**INTEGRATED CIRCUITS, SILICON MONOLITHIC,
CMOS 4-BIT LATCH/4-TO-16-LINE DECODER,
BASED ON TYPE 4514B**

ESA/SCC Detail Specification No. 9408/012

DOCUMENTATION CHANGE NOTICE

FIGURE 2(a) - FLAT PACKAGE, 24-PIN

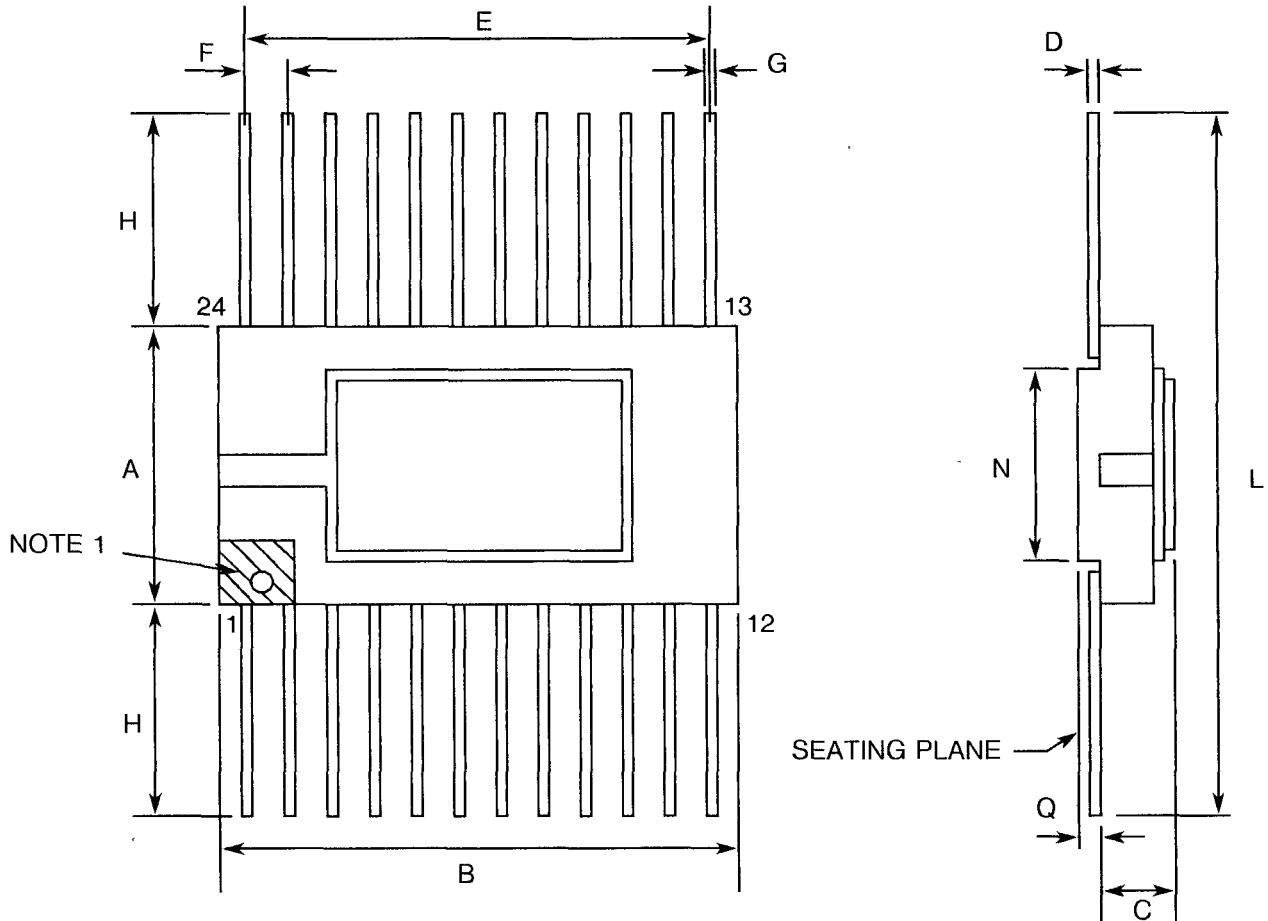
| Rev. Letter | Rev. Date | Reference | CHANGE Item | Approved DCR No. |
|-------------|-----------|-------------------------------------------------------------------------------------------------------------------------------|---------------------------------------------------------------------------------------------|------------------|
| | | Figure 2(a) | : Table corrected | 23247/ 23270 |

FIGURE 2(b) - DUAL-IN-LINE PACKAGE, 24-PIN

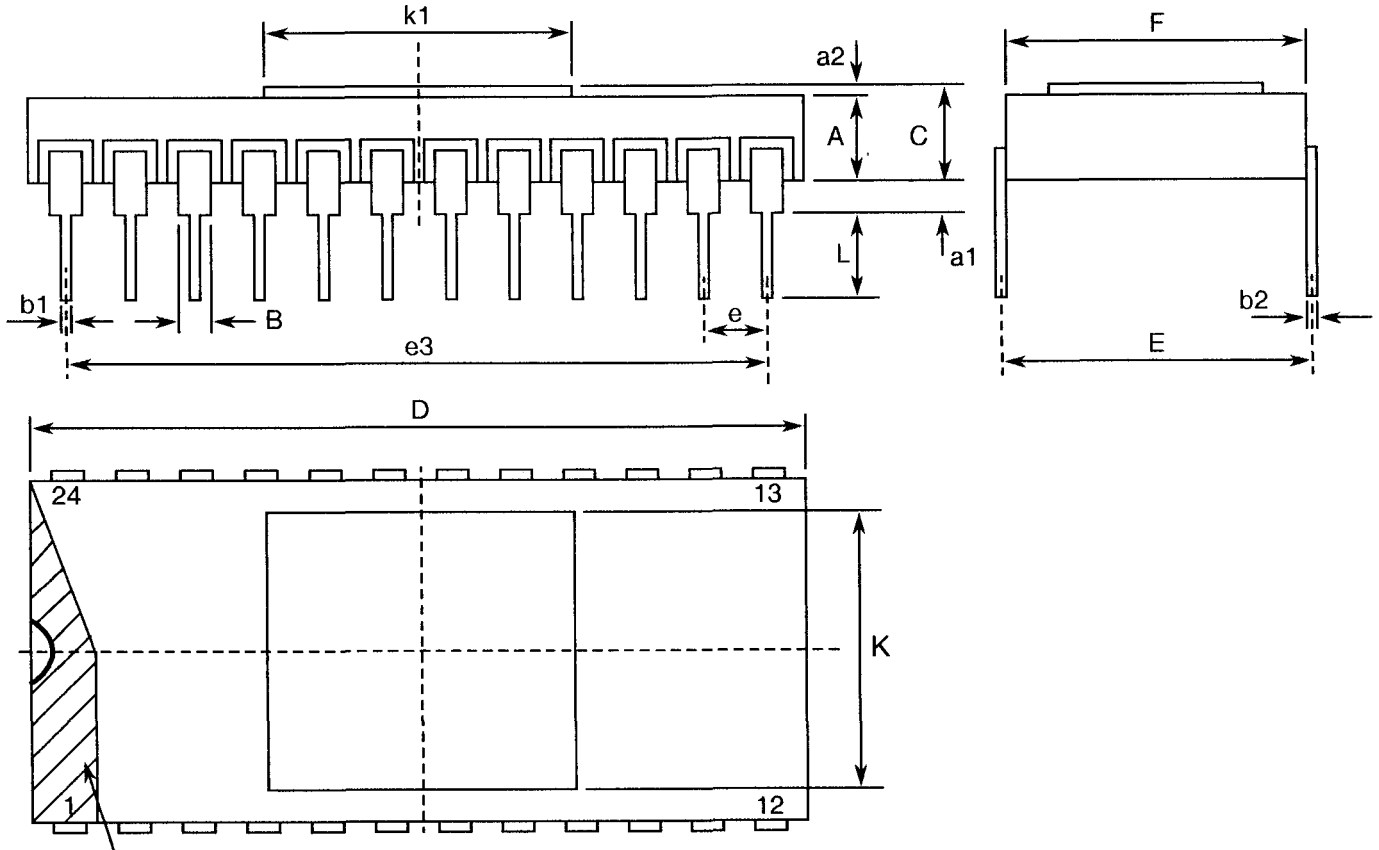
| Rev. Letter | Rev. Date | Reference | CHANGE Item | Approved DCR No. |
|-------------|-----------|-------------------------------------------------------------------------------------------------------------------------------|---------------------------------------------------------------------------------------------|------------------|
| | | Figure 2(b) | : "CKT A" deleted from Title | 22398 |

FIGURE 2(c) - CHIP CARRIER - 28-TERMINAL

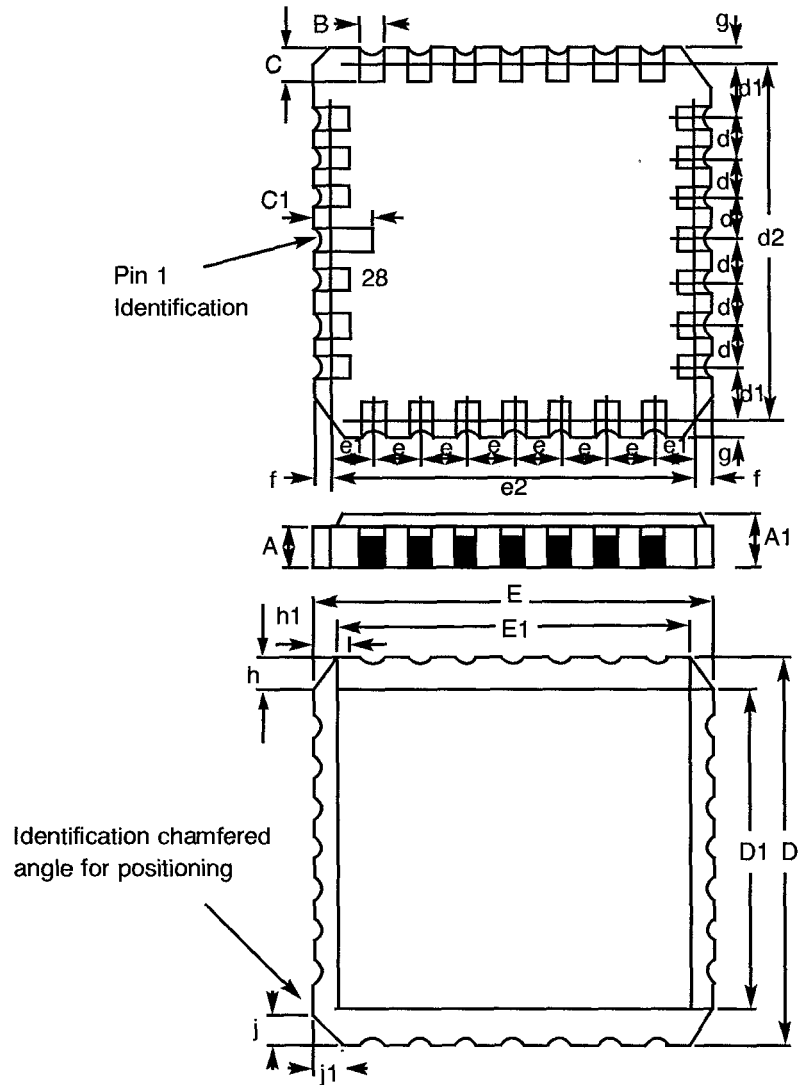
| Rev. Letter | Rev. Date | Reference | CHANGE Item | Approved DCR No. |
|-------------|-----------|-------------------------------------------------------------------------------------------------------------------------------|---------------------------------------------------------------------------------------------|------------------|
| | | Figure 2(d) | : Title amended to "2(c)" | 22398 |
| | | | : Table corrected | 23247 |

FIGURE 3(c) - CIRCUIT SCHEMATIC

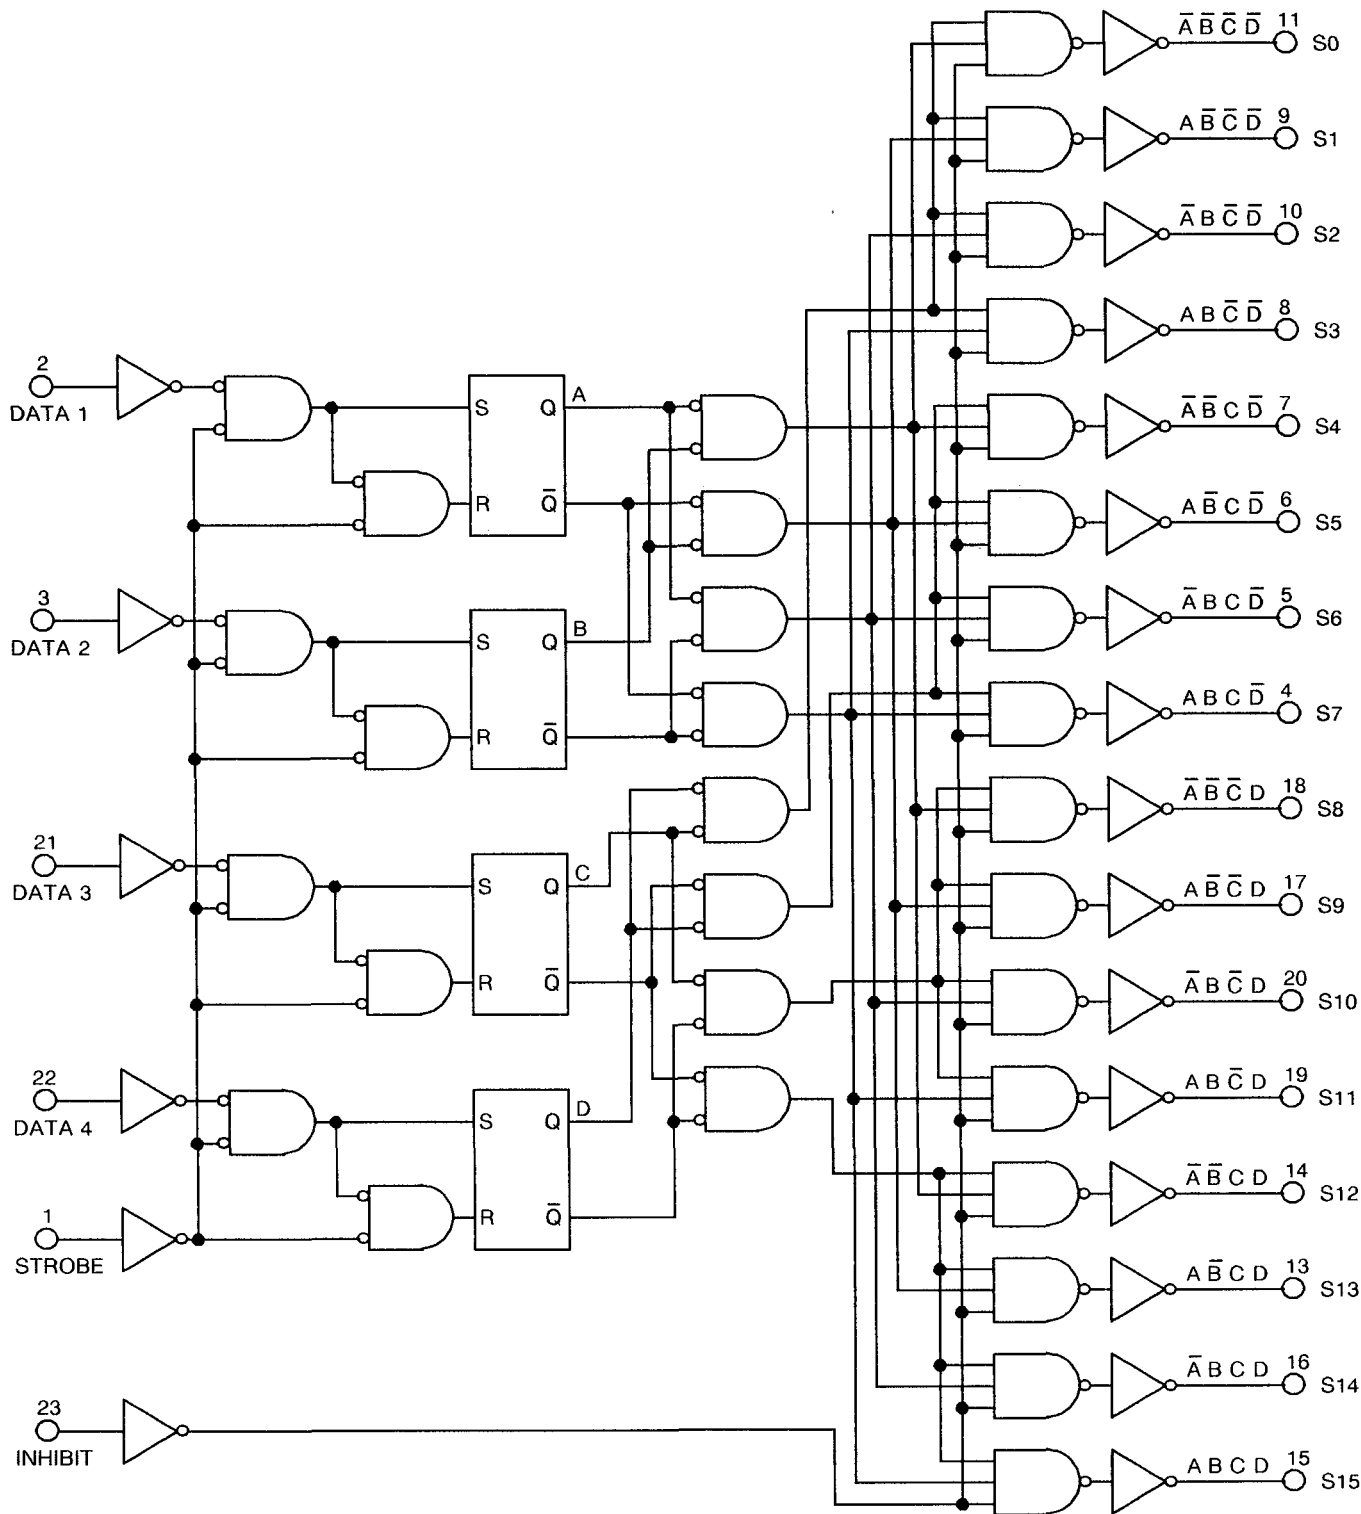
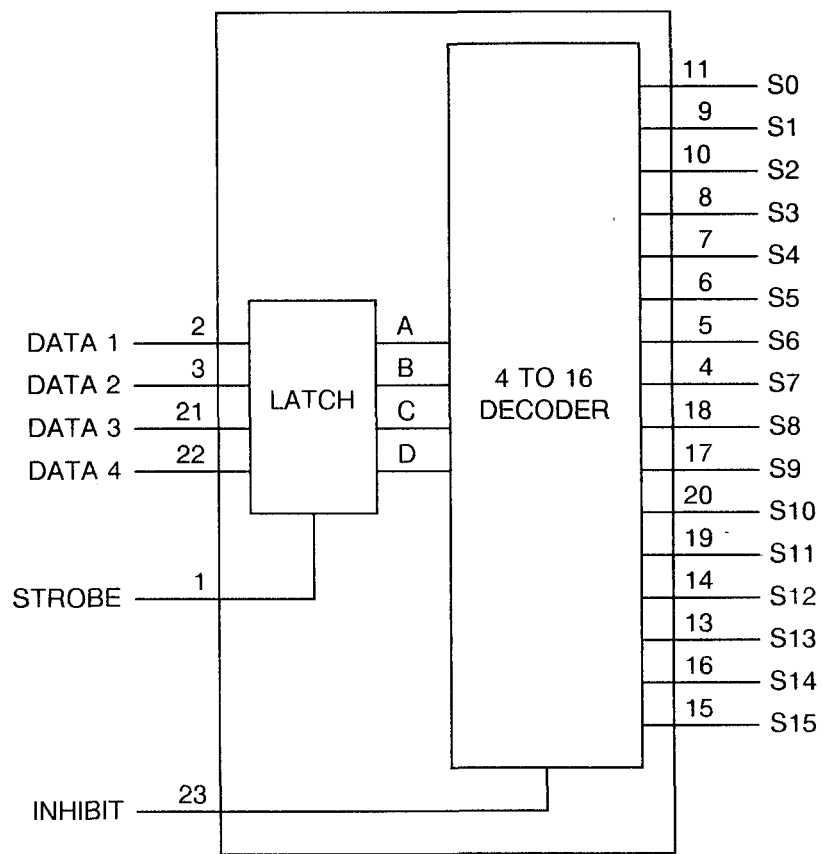
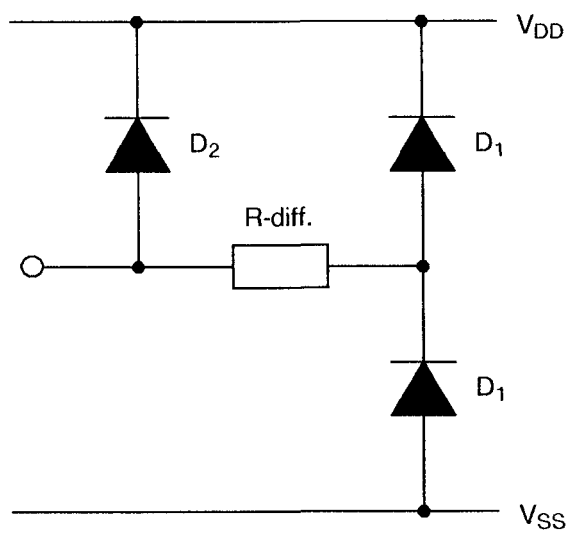
| Rev. Letter | Rev. Date | Reference | CHANGE Item | Approved DCR No. |
|-------------|-----------|-------------------------------------------------------------------------------------------------------------------------------|---------------------------------------------------------------------------------------------|------------------|
| | | Figure 3(c) | : Entry deleted and drawing from Figure 3(d) added | 23517 |
| | | Figure 3(d) | : Drawing transferred to Figure 3(c) and Right Hand drawing from Figure 3(a) added | 23517 |
| | | Figure 3(e) | : Figure corrected | 23517 |

FIGURE 4(c) - LOW LEVEL INPUT CURRENT

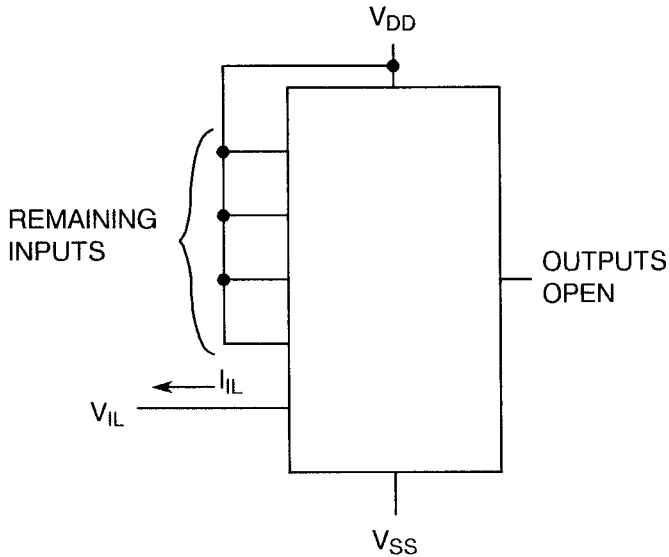
| Rev. Letter | Rev. Date | Reference | CHANGE Item | Approved DCR No. |
|-------------|-----------|-------------------------------------------------------------------------------------------------------------------------------|---------------------------------------------------------------------------------------------|------------------|
| | | Figure 4(c) | : In drawing, "Remaining Inputs" corrected | 23517 |

FIGURE 4(e) - LOW LEVEL OUTPUT VOLTAGE

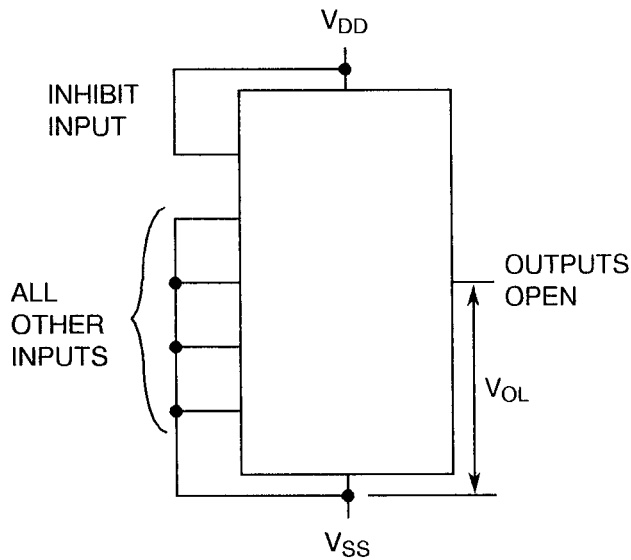
| Rev. Letter | Rev. Date | Reference | CHANGE Item | Approved DCR No. |
|-------------|-----------|-------------------------------------------------------------------------------------------------------------------------------|---------------------------------------------------------------------------------------------|------------------|
| | | Figure 4(e) | : In drawing, "All Other Inputs" added | 23517 |

FIGURE 4(f) - HIGH LEVEL OUTPUT VOLTAGE

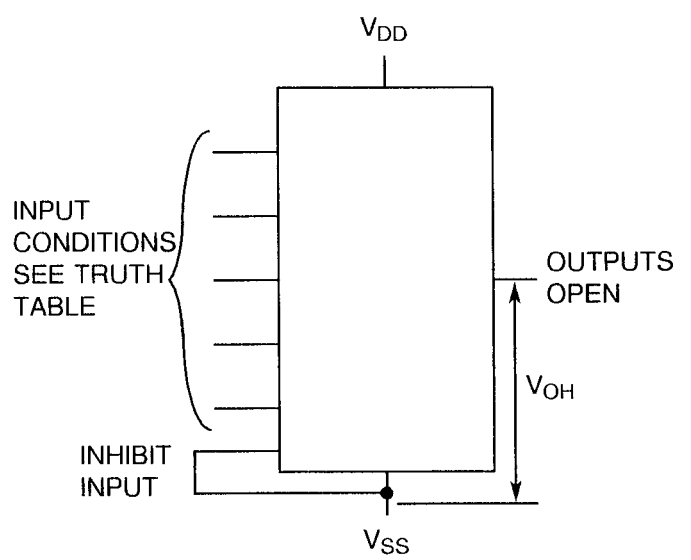
| Rev. Letter | Rev. Date | Reference | CHANGE Item | Approved DCR No. |
|-------------|-----------|-------------------------------------------------------------------------------------------------------------------------------|---------------------------------------------------------------------------------------------|------------------|
| | | Figure 4(f), (h) | : Input to V _{SS} marked "Inhibit Input" added | 23517 |

FIGURE 4(g) - LOW LEVEL OUTPUT CURRENT

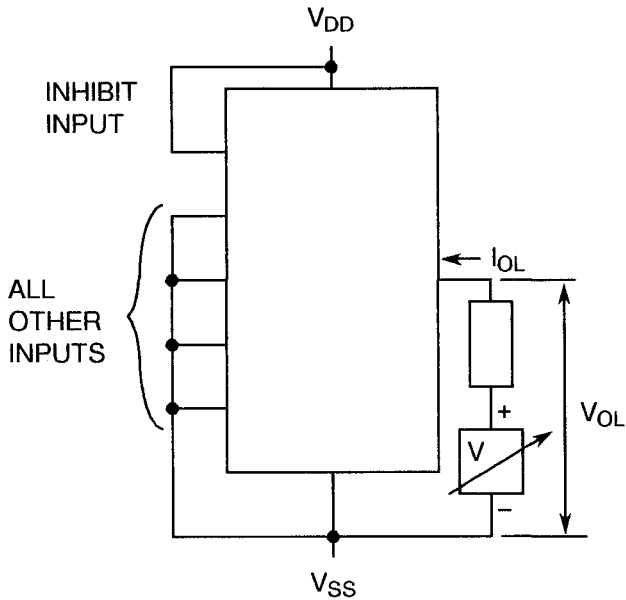
| Rev. Letter | Rev. Date | Reference | CHANGE Item | Approved DCR No. |
|-------------|-----------|-------------------------------------------------------------------------------------------------------------------------------|---------------------------------------------------------------------------------------------|------------------|
| | | Figure 4(g) | : "Inhibit Input" connected to "V _{DD} " | 23517 |
| | | Figure 4(g), (h) | : Output circuits amended | 23076 |
